FINAL PLAT
THE WATERFRONT SECOND ADDITION
AN ADDITION TO WICHITA, SEDGWICK COUNTY, KANSAS

RE: SUB 2002-128 -- Revised One-Step Final Plat of The Waterfront Second Addition

At the regular meeting of the Subdivision Committee of the Metropolitan Area Planning Commission on Thursday, September 11, 2003, the above captioned plat was considered. The action of the Committee was to approve the final plat, subject to the following staff comments:

CASE NUMBER: SUB 2002-128 -- THE WATERFRONT SECOND ADDITION

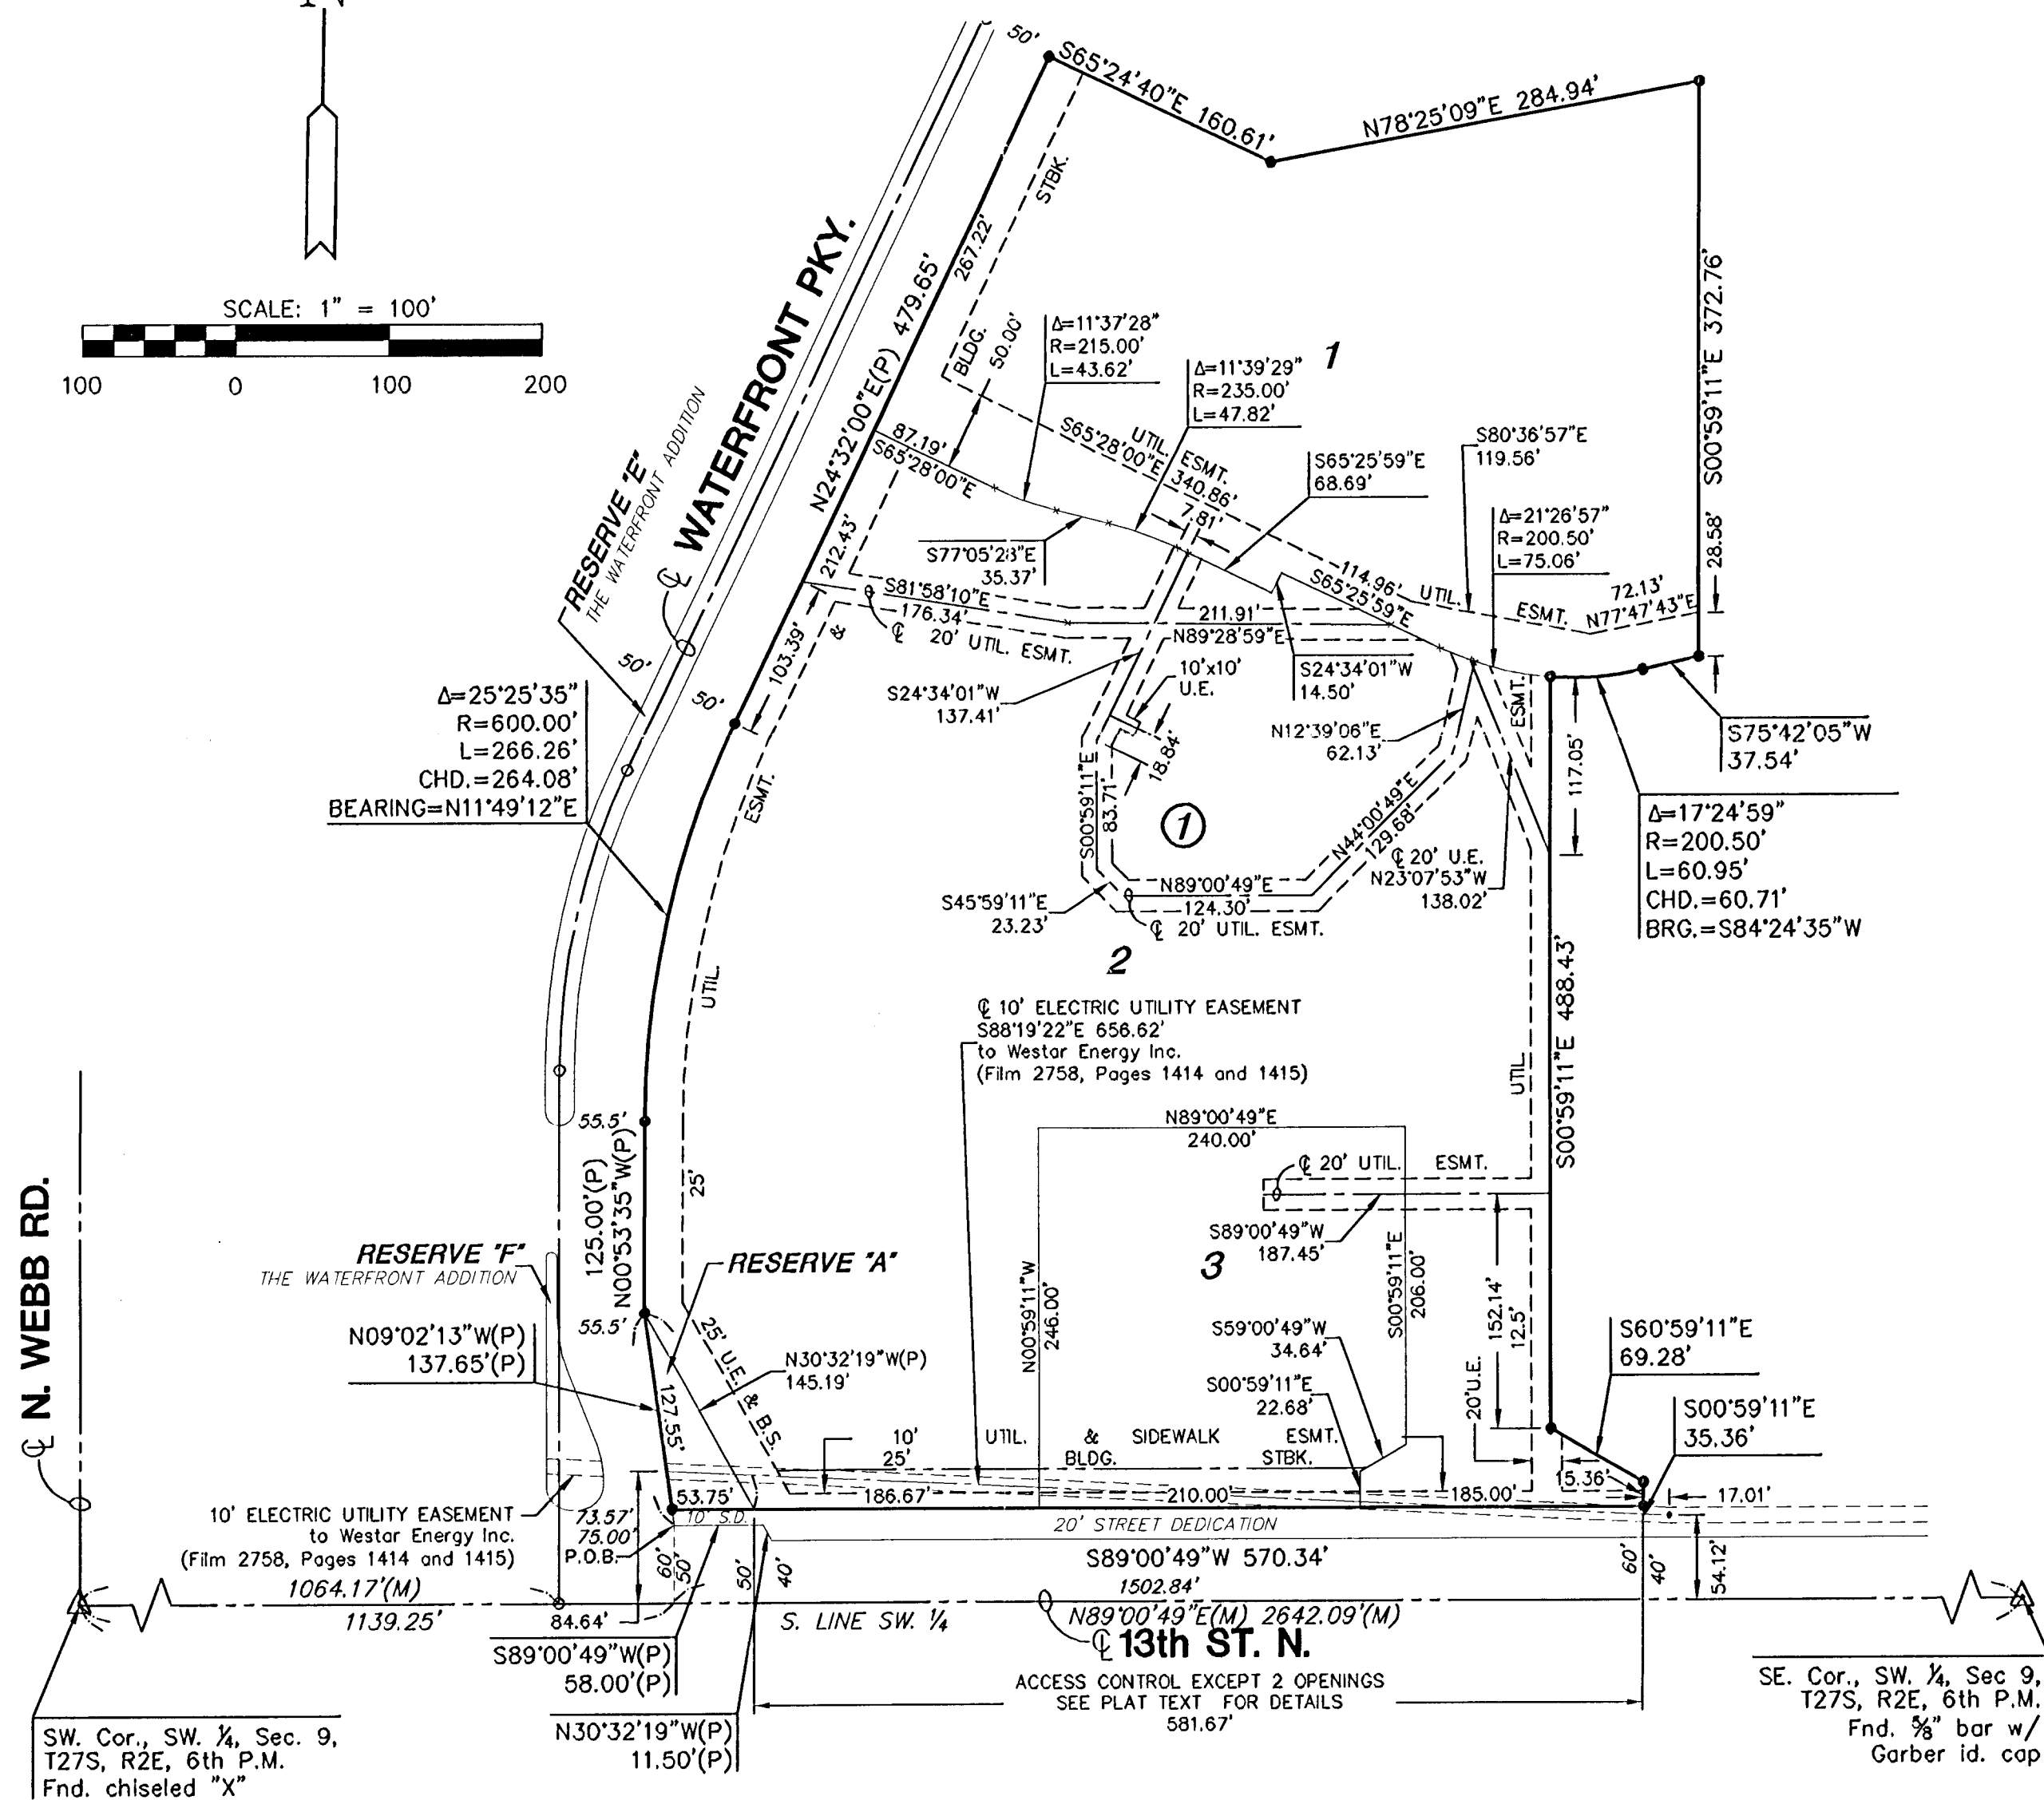
- C. **City Engineering** needs to comment on the status of the applicant's drainage plan. *The drainage plan is approved.*
- D. The plat proposes two access openings along 13th Street in accordance with minimum spacing standards of the access management regulations.

- E. "13th St N" shall be correctly denoted on the plat.
- F. **Traffic Engineering** has requested a petition for a left turn lane into the full movement drive.

- G. **County Surveying** advises that the 30-ft utility easement needs located.
- H. The applicant shall submit an avigational easement covering all of the subject plat and a restrictive covenant assuring that adequate construction methods will be used to minimize the effects of noise pollution in the habitable structures constructed on subject property.

- J. The signature line for the City Clerk needs to be revised to reference "Karen Schofield".
- K. The MAPC signature block needs to reference "Ronald L. Marnell, Chair".

- L. The platlor's text shall include language that a drainage plan has been developed for the plat and that all drainage easements, rights-of-way, or reserves shall remain at established grades or as modified with the approval of the applicable City or County Engineer, and unobstructed to allow for the conveyance of stormwater.
